## EQUUS BEDS GROUNDWATER MANAGEMENT DISTRICT NO. 2

Re: Application No. 45567 – City of Wichita

APPLICATION REVIEW INFORMATION

Figure 3. – Basin Storage Area Map - Application No. 45576 Site Map - SW 12-23S-3W  
Prepared by: Equus Beds Groundwater Management District No. 2 - 06/30/04

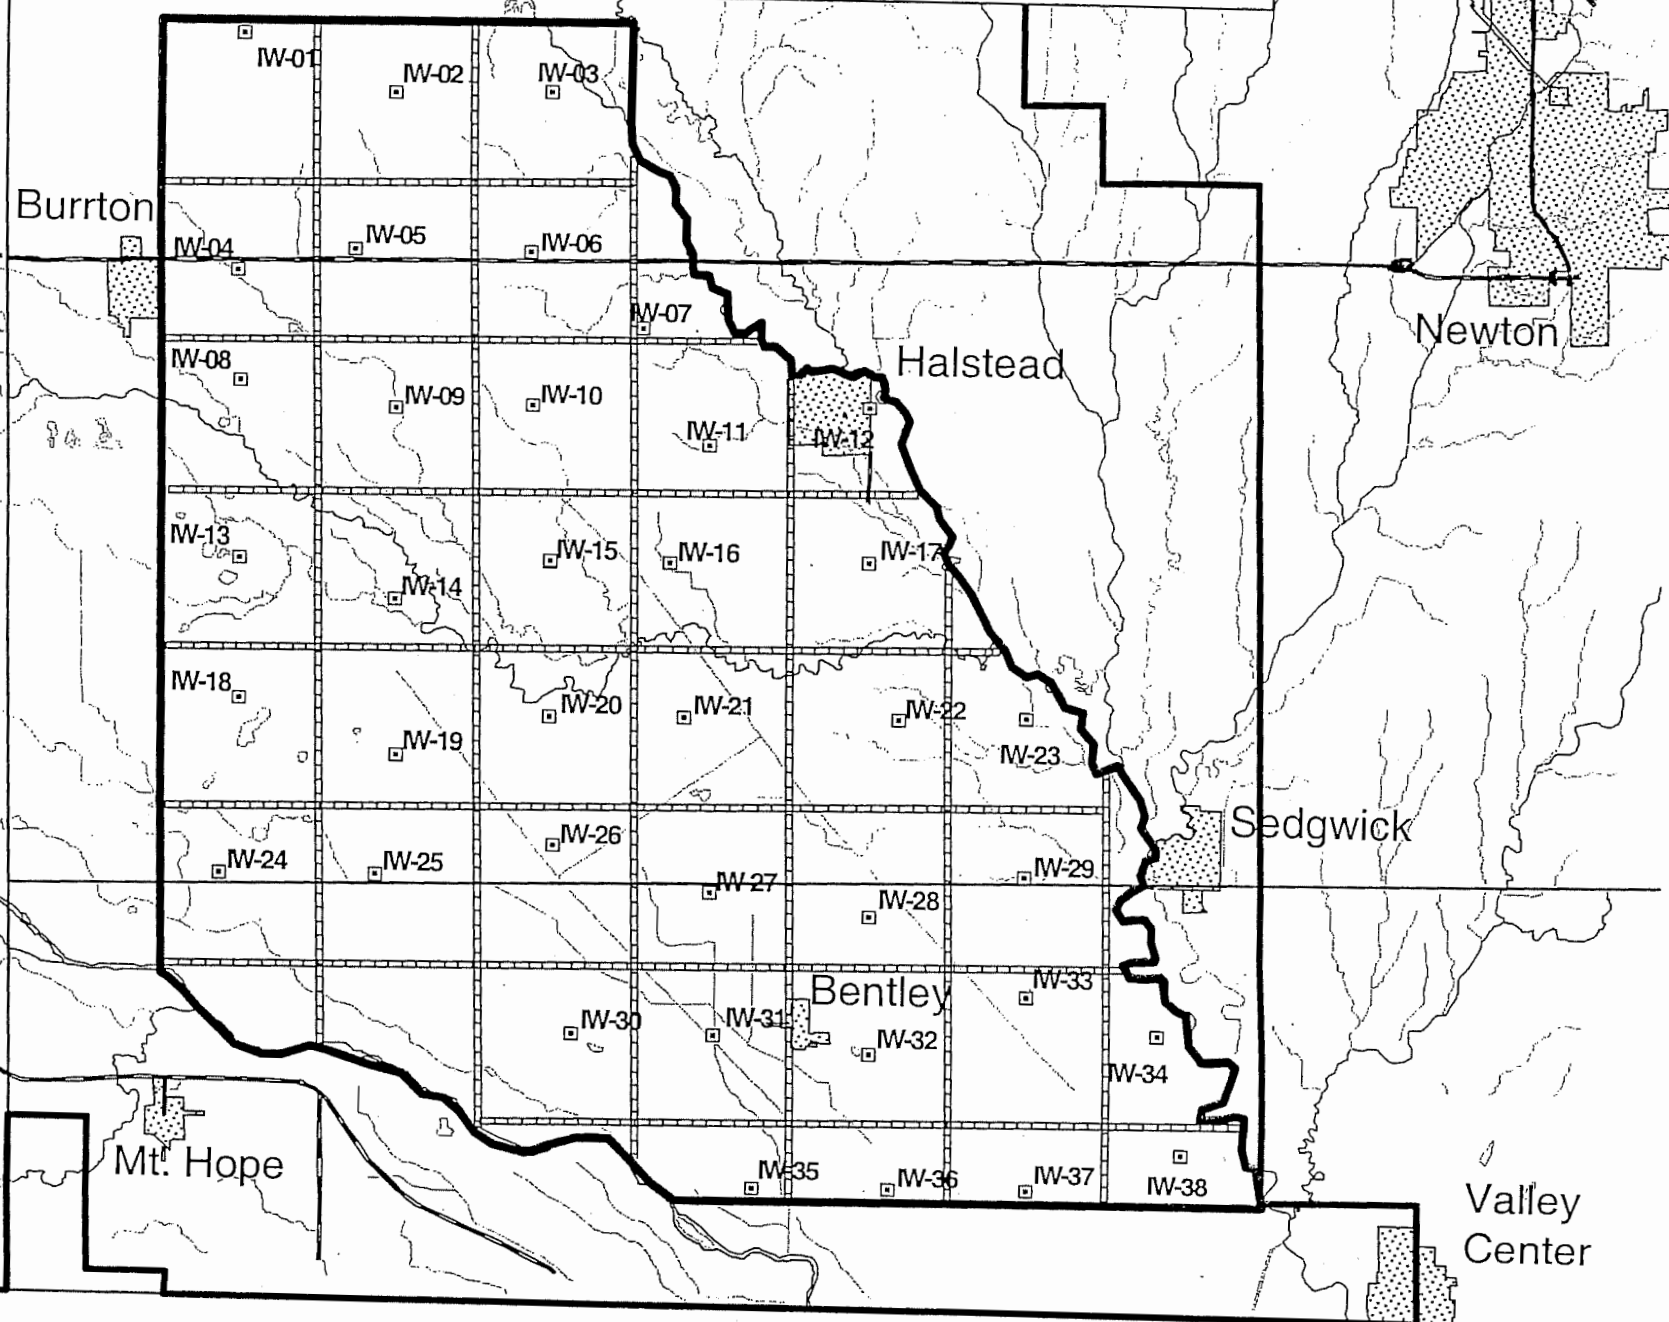
The applicant's proposal for aquifer storage will consist of a basin storage area underlying an area approximately 92,720 acres in size (figure 3). The following Division of Water Resources regulations as defined by K.A.R. 5-5-1, shall apply to the ASR project:

Based on Kansas Geological Survey methodology for optimum monitoring well network design, the basin storage area was sub-divided into of 38 water budget accounting units, each comprised of a four square mile area (figure 3). Each unit consists of a monitoring well site utilized to obtain index water levels, and water quality data.

- 4) as determined by Kansas Geological Survey methodology the basin storage area is divided into 38 water budget accounting units and each unit is assigned an index identification number as shown on figure 3;

**Figure 4. – Application No. 45576 Site Map - SW 12-23S-3W**  
 Prepared by: Equus Beds Groundwater Management District No. 2 - 07/06/04

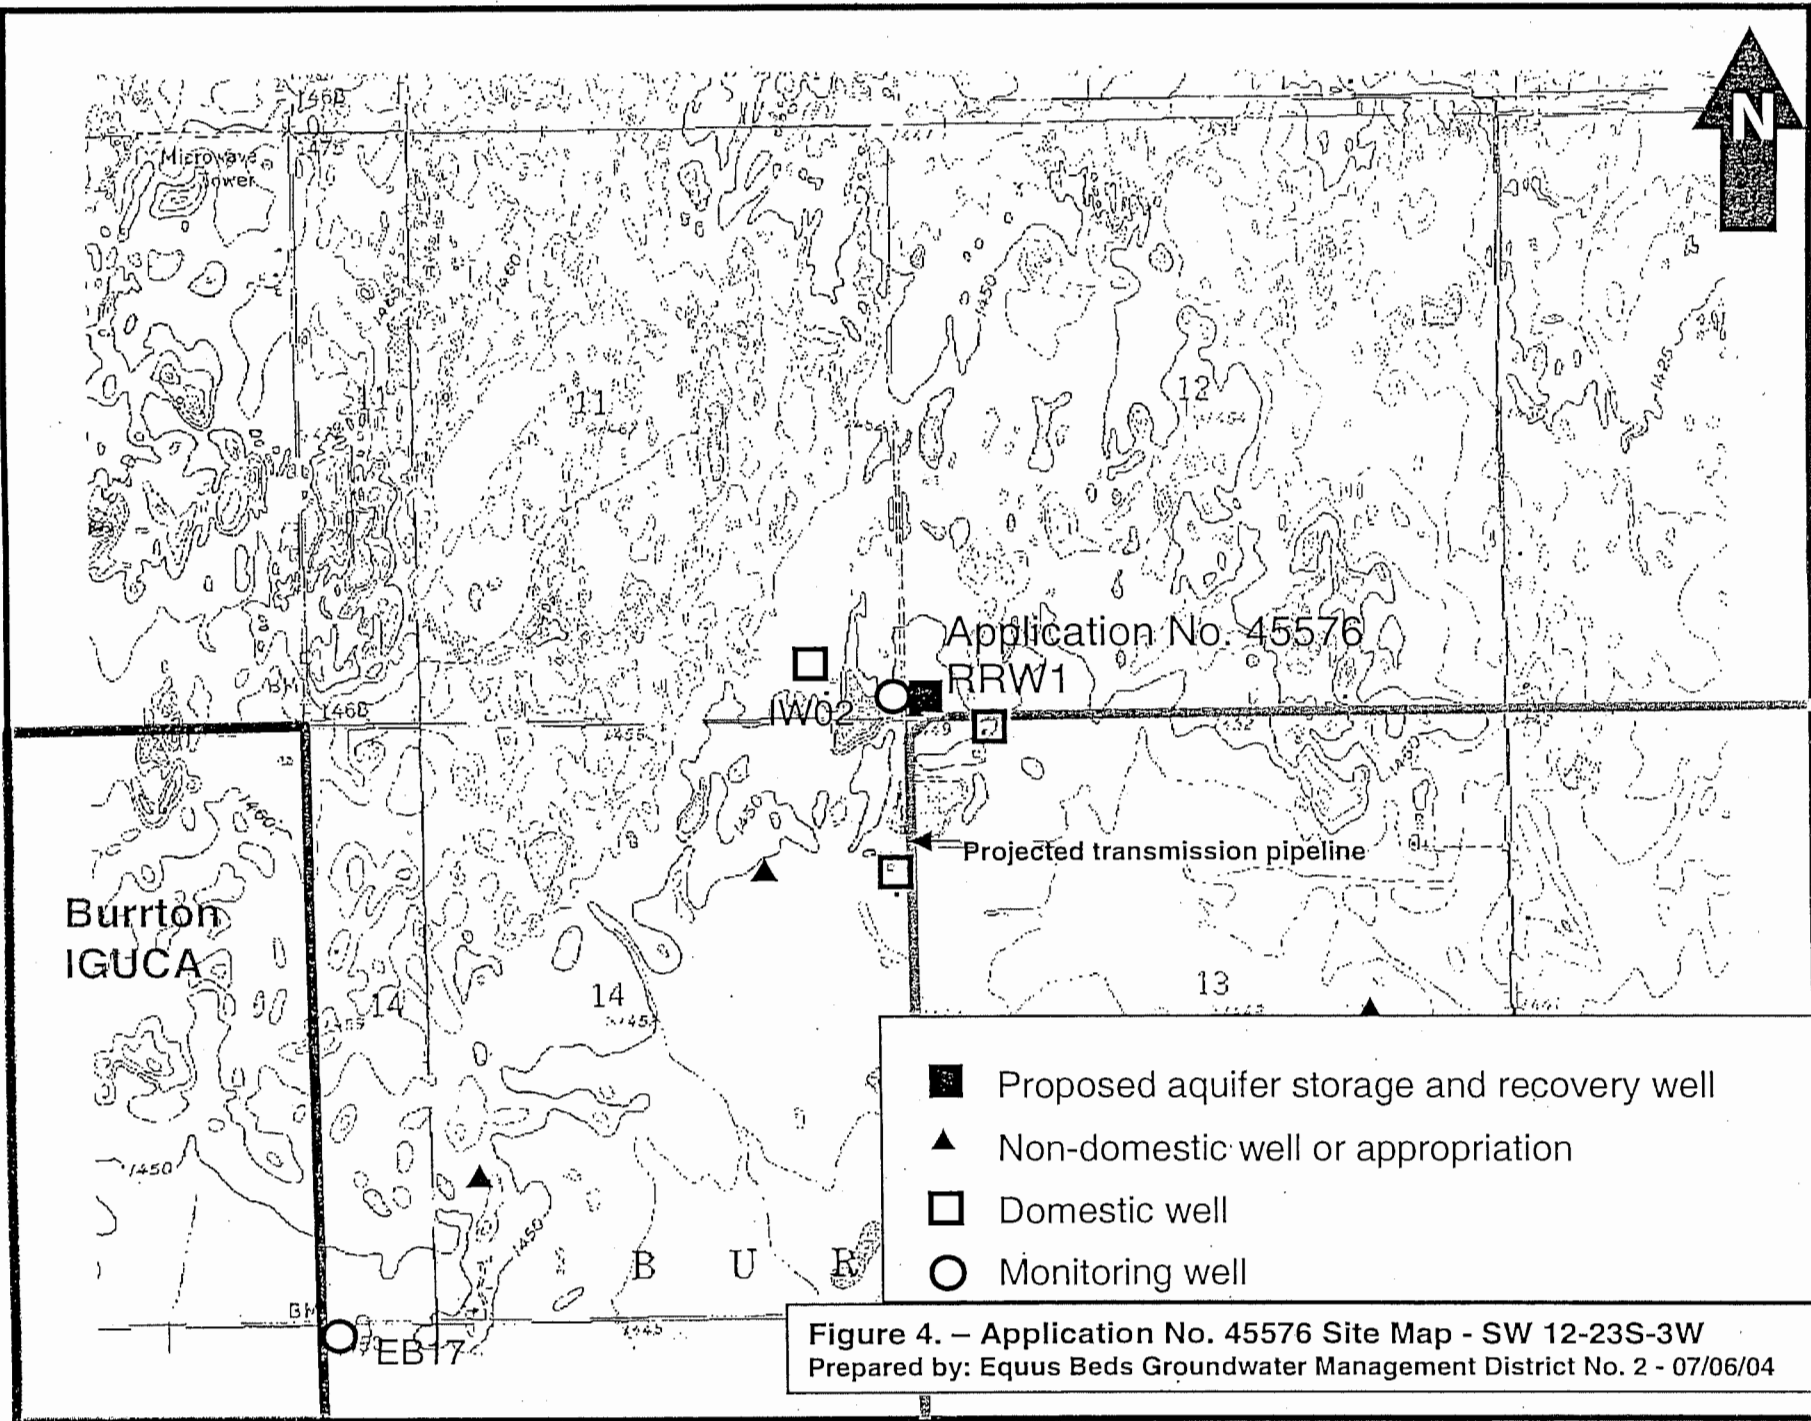
The proposed ASR well is located in the SW-SW-SW of Section 12, Township 23 South, Range 3 West (figure 4), and at a point near the center of basin storage unit no. 2 (figure 5).

Water level data has been recorded by the District at groundwater monitoring site IW02 located within 100 feet of the proposed ASR well site (figure 4). Water levels recorded at the site during the period of record from October 2001 to April 2004 (figure 8), indicated that a perched water table existed at a depth of 26 feet bls. Water levels ranged from 4.07 to 10.07 feet in IW02A (total depth 26 feet). Water level data for IW02C ranged from 33.68 to 53.27 feet (total depth 95 feet) during the period of record. The IW02C lithologic log reported that depth to bedrock was 149 feet bls, with the lowest sand unit from 75 to 115 feet bls.

Figure 6. – Application No. 45576 Site Map - SW 12-23S-3W  
 Prepared by: Equus Beds Groundwater Management District No. 2 - 06/30/04

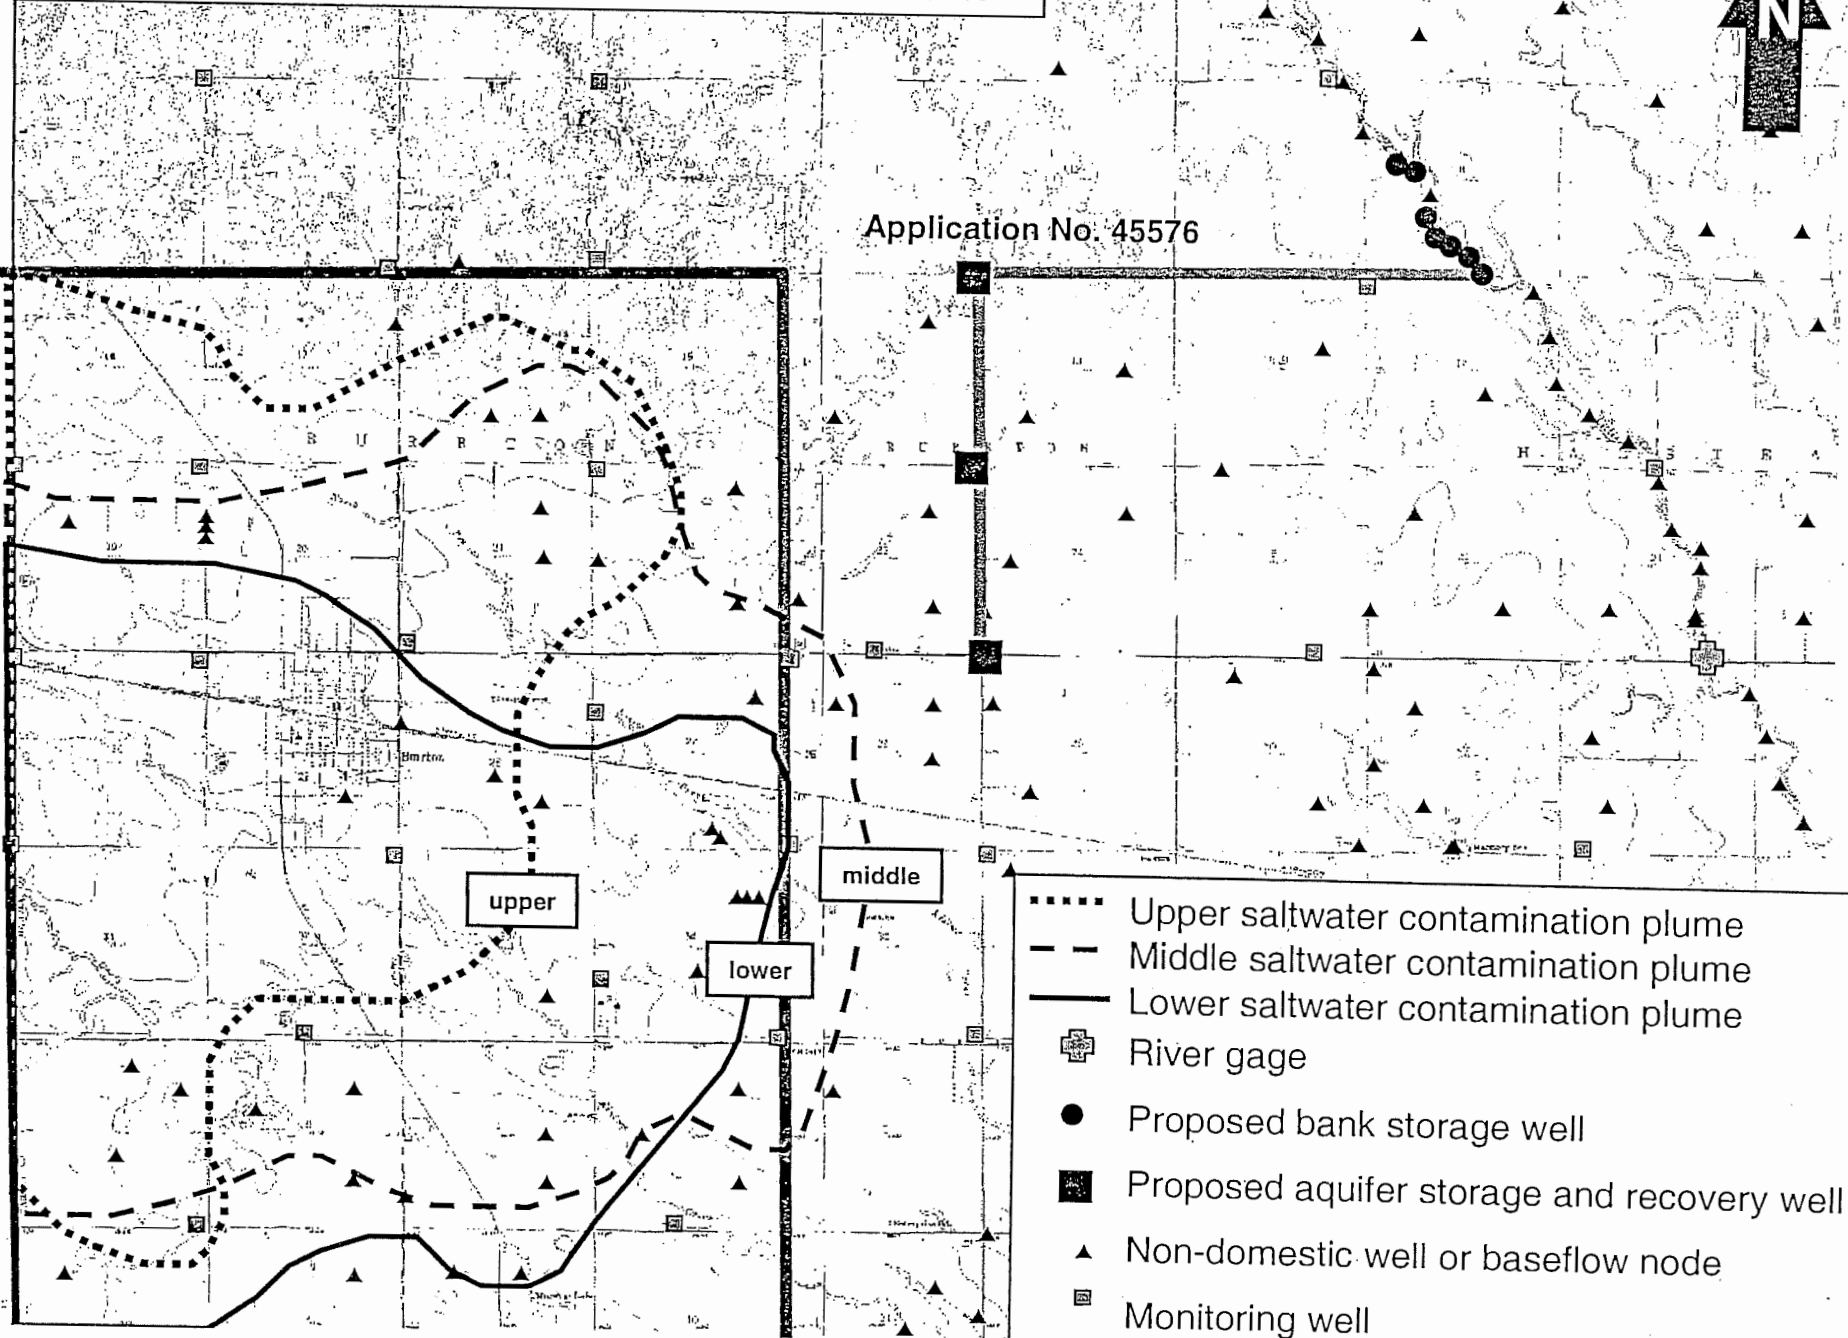
The proposed ASR well is located one mile east of the Burrton Intensive Groundwater Use Control Area Boundary (figure 6). Saltwater contamination plumes with chloride concentrations greater than 250 mg/L, are located southwest of the proposed well site (figure 6). The nearest saltwater plumes are in the upper (depth 66 feet bls) and middle (depth 152 feet bls) portions of the aquifer located approximately 1.8 miles southwest of the application and moving to the southeast.

Figure 7. – Application No. 45576. Lithologic Log for Test Well at Proposed ASR Well Site

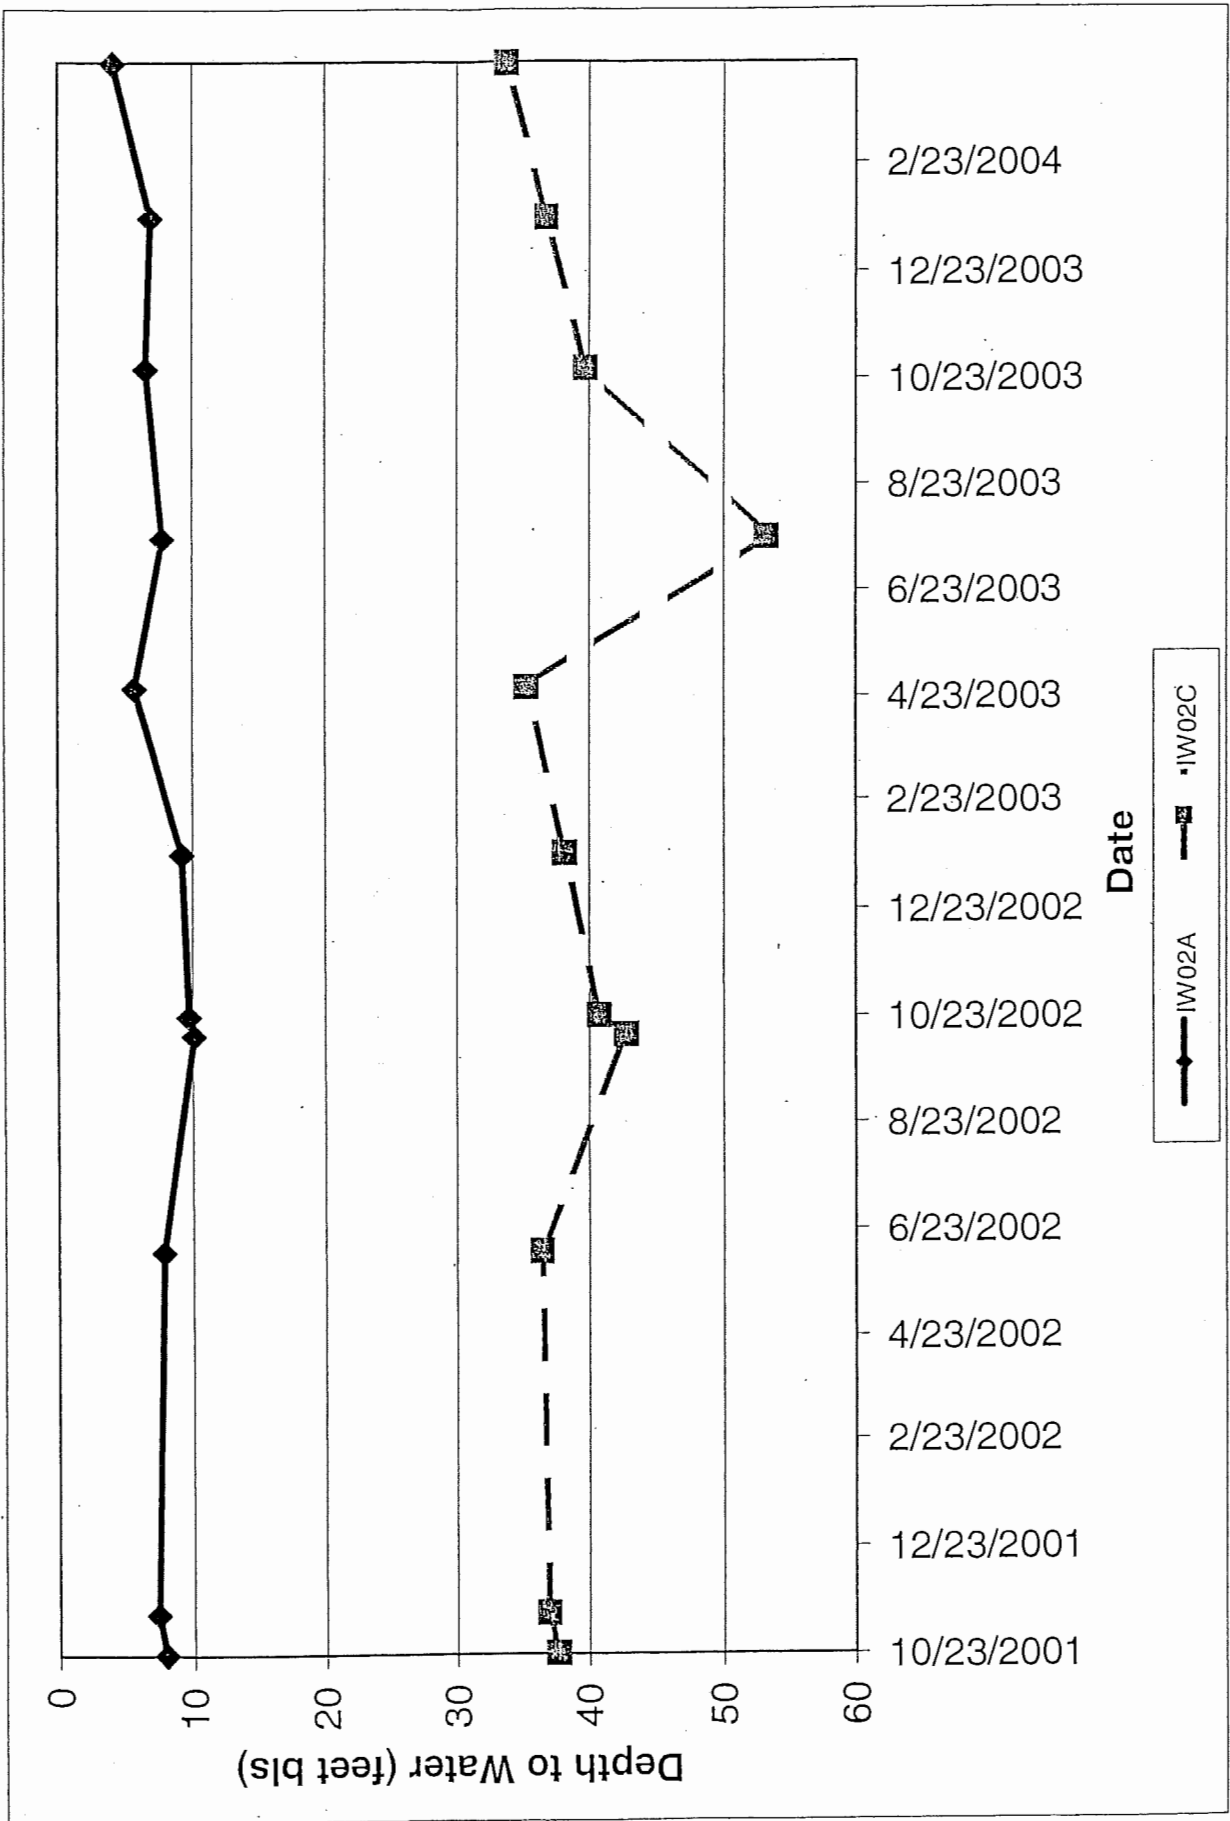
The lithologic log of the proposed well site indicates that the aquifer is comprised of alternating sand and clay layers (figure 7). The clay units range from 1 to 31 feet in thickness. The sand units range from 4 to 15 feet in thickness, with the 15 feet thick unit located from a depth of 109 to 124 feet below land surface.
